# Test Symbol Error Extrapolation

802.3dj ad-hoc

# Overview

# Example of current definition

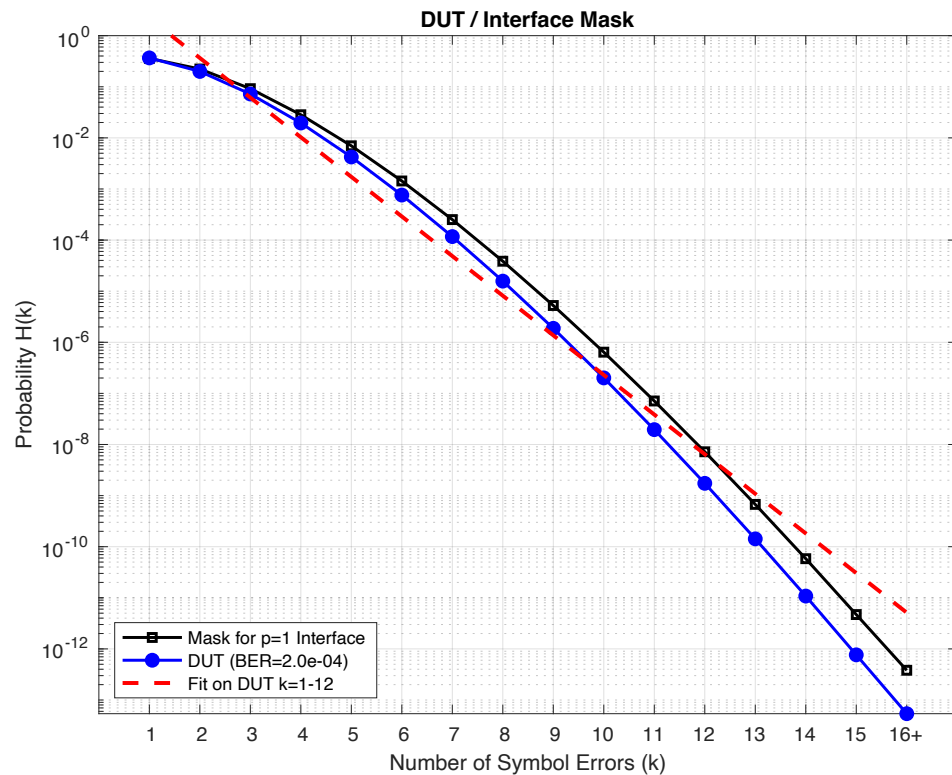
The red line is a linear fit from 1 to 12 symbol errors

- This is the extrapolation defined in D3.0

# Options Comparison

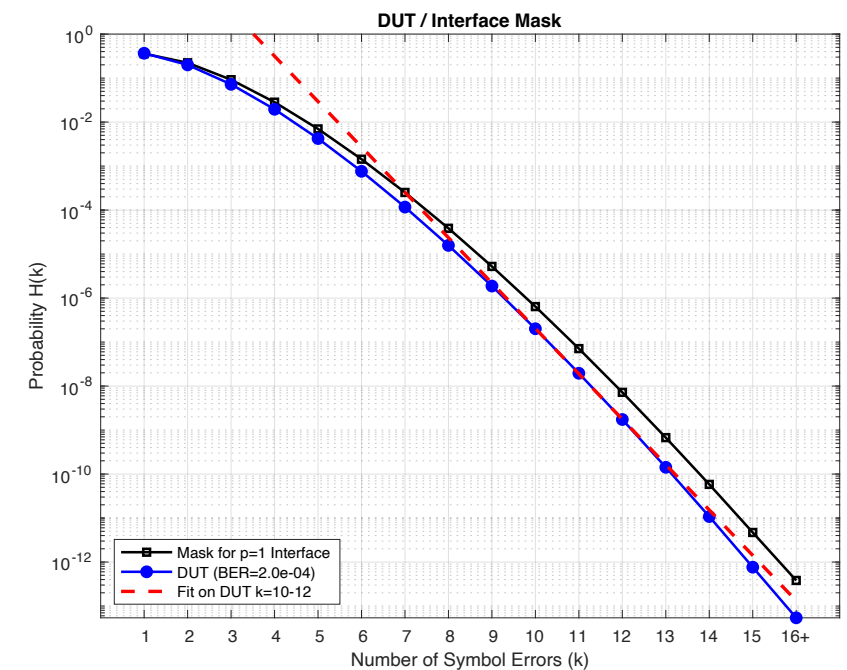
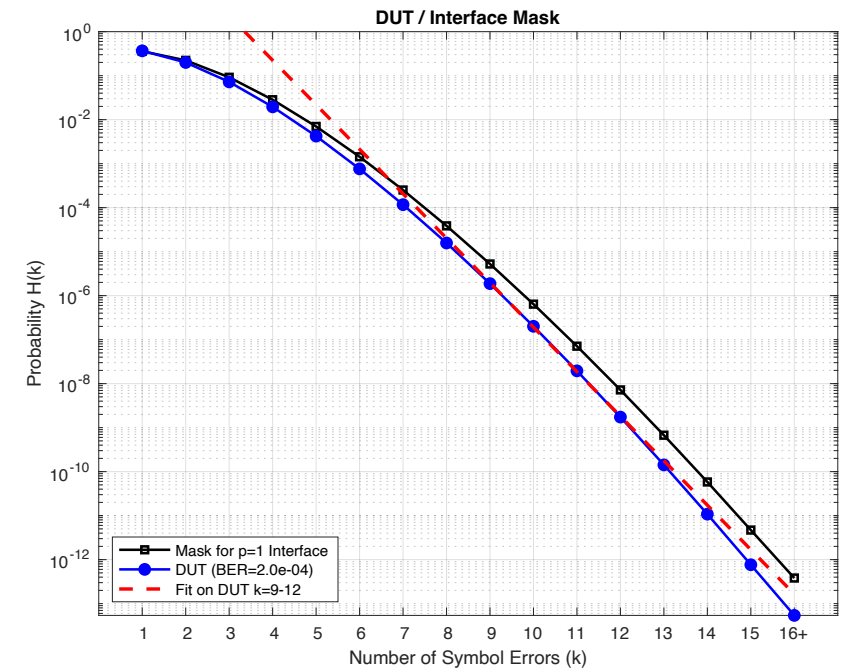
- Fit using  $k = 9-12$ , based on bin 12 having  $> 2$  occurrences
- Fit will use highest 4 points

- Fit on  $k= 10-12$ , based on bin 12 having  $> 2$  occurrences AND bin 10 being  $< 1e-6$

Both extrapolations are an improvement

# Highest Bin statistical variation

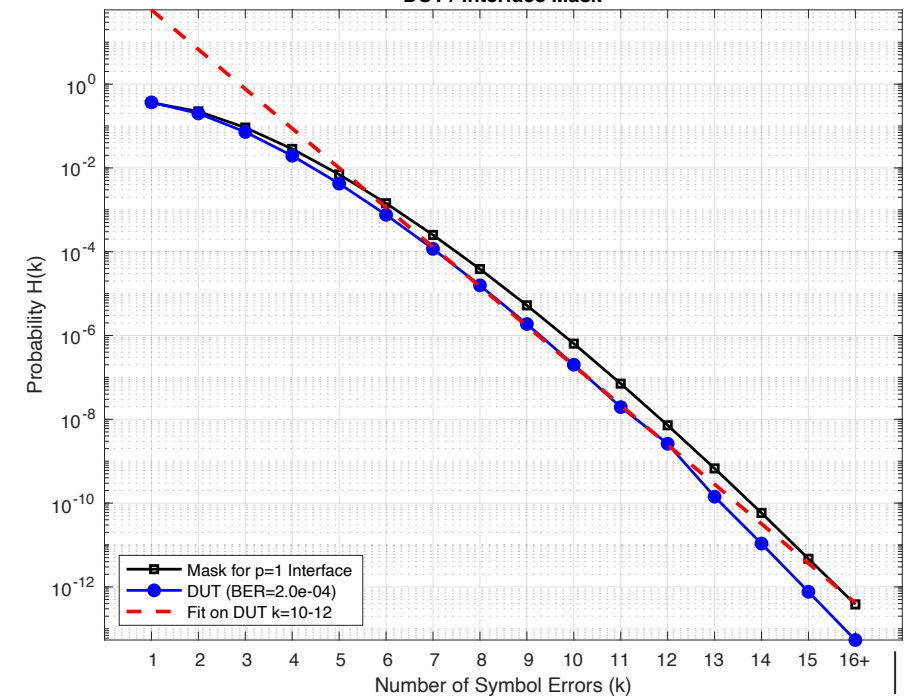
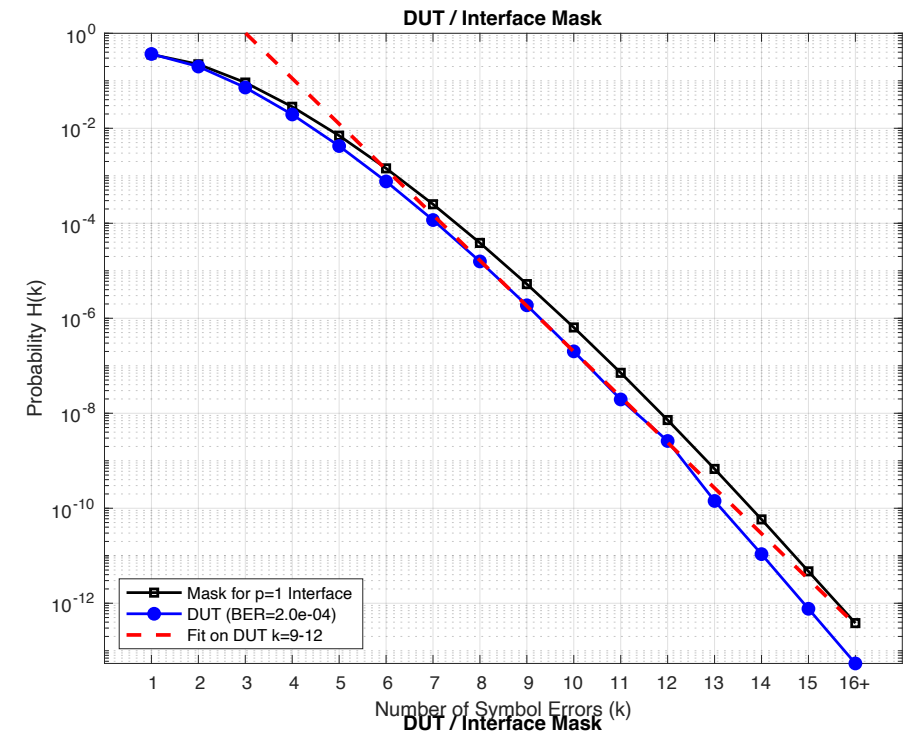
Because the points used in current definition are those with only 3 events, there will be variations in last point

On the right curves for a  $2E-4$  BER are shown, with bin 12 being a 10% probability (mean = 4, 6 counts ~10% probability)

Using two counts in highest bin may be too low

In this case probability screen to  $\leq 1e-6$  has 3 bins

Using 4 bins is slightly closer to correct.
